CERTIFICATE OF APPROPRIATENESS

Property: 1917 Crockett St, Lot 1, Block 314, Shearn Addition Subdivision. The property is a vacant 2,315 square foot (47' x 49'-3") corner lot.

Proposal: New Construction – Residence

Recommendation: Deferral

WEST ELEVATION – FACING WHITE STREET

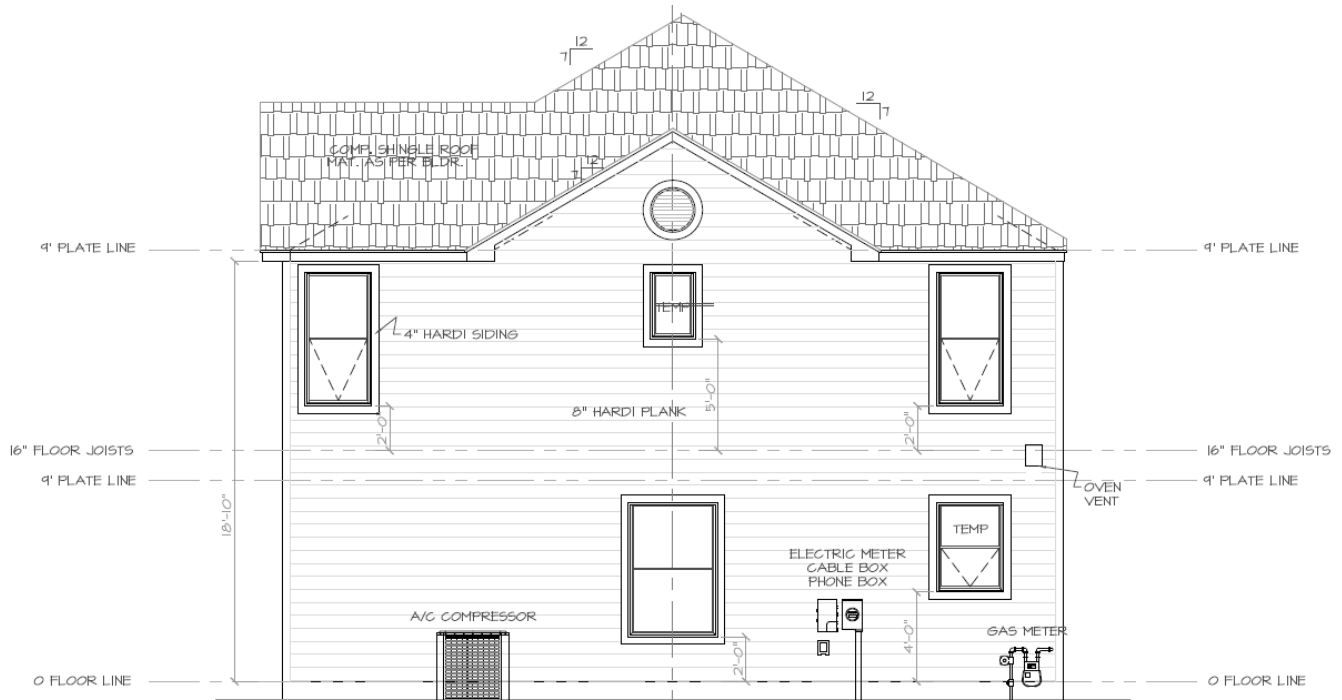
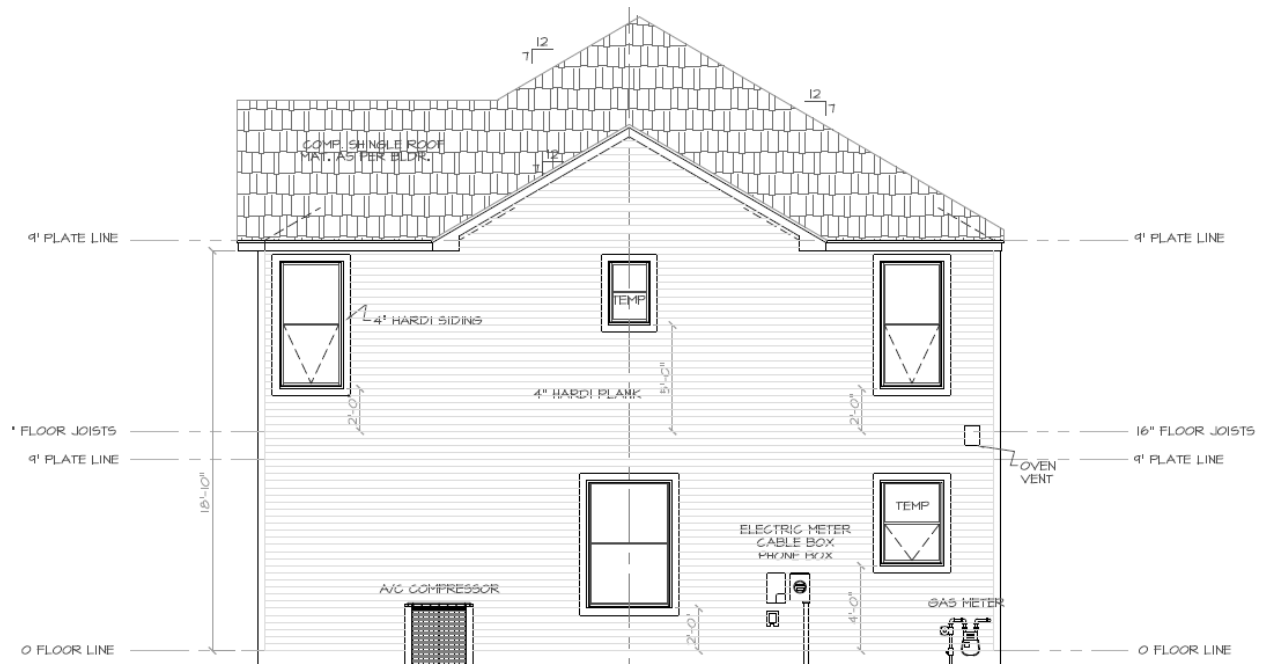
- ☐ ☒ ☐ (2) The exterior features of the new construction must be compatible with the exterior features of existing contributing structures in the context area;
*The residence is clad in smooth-finish 4" reveal horizontal lap cementitious siding and contains 1-over-1 windows.
The front porch is only 4' deep where typical porch depths are between 6-8 feet deep. The south and west elevations are also lacking window openings in keeping with typical contributing structures in the area. If the porch were adjusted to be at least 6' deep and additional, symmetrical window openings added on the west and south elevations, the design would meet criteria.*

The draft Design Guidelines also require traditional solid-to-void proportions for walls to windows. The south and west elevations lacks window openings, which is not in keeping with typical contributing structures in the area and therefore does not meet this provision.

SITE PLAN

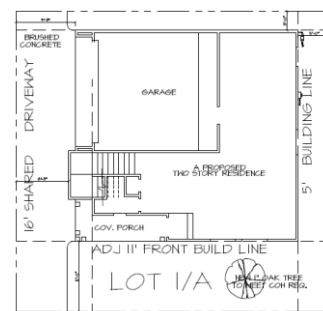
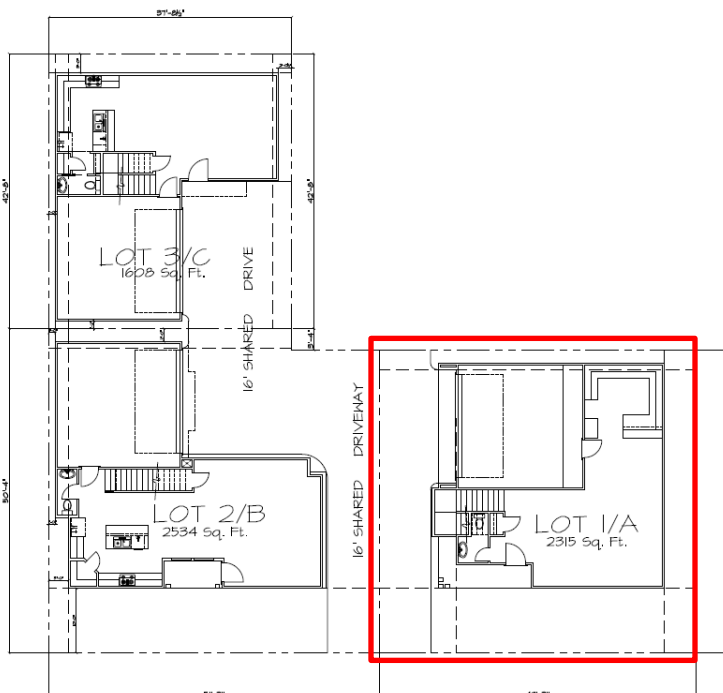
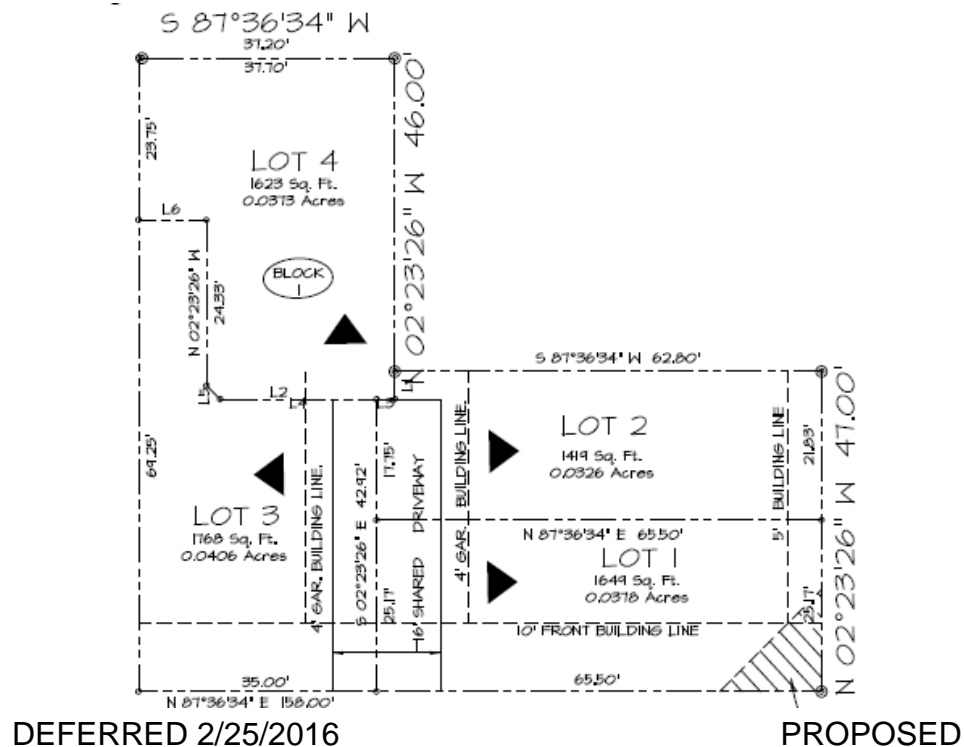
- 1.1. A site plan is required for a COA application. Each of these applications includes a drawing labeled "Site Plan". However, these purported site plans do not indicate the orientation of the proposed buildings to the surrounding streets or to each other. In addition, the elevations are listed as "left", "right", etc. instead of the usual "north", "south" etc. All this is contrary to industry standards, and makes the site plans are very difficult to decipher. This needs to be addressed in order to make the proposed plans more readily understandable.

- 1.2. Given the close proximity and interrelationships of the proposed buildings with one another, a site plan should be provided that covers all the buildings in the project so that what is being proposed can be understood.

- 1.4. The historic/contributing structure at 1907 Crockett is known to encroach on its neighbor to the west (1913 Crockett). This encroachment is not shown on the site plan. This omission is significant, since it affects the actual distance that will separate the new structure at 1913 from the existing one at 1907.
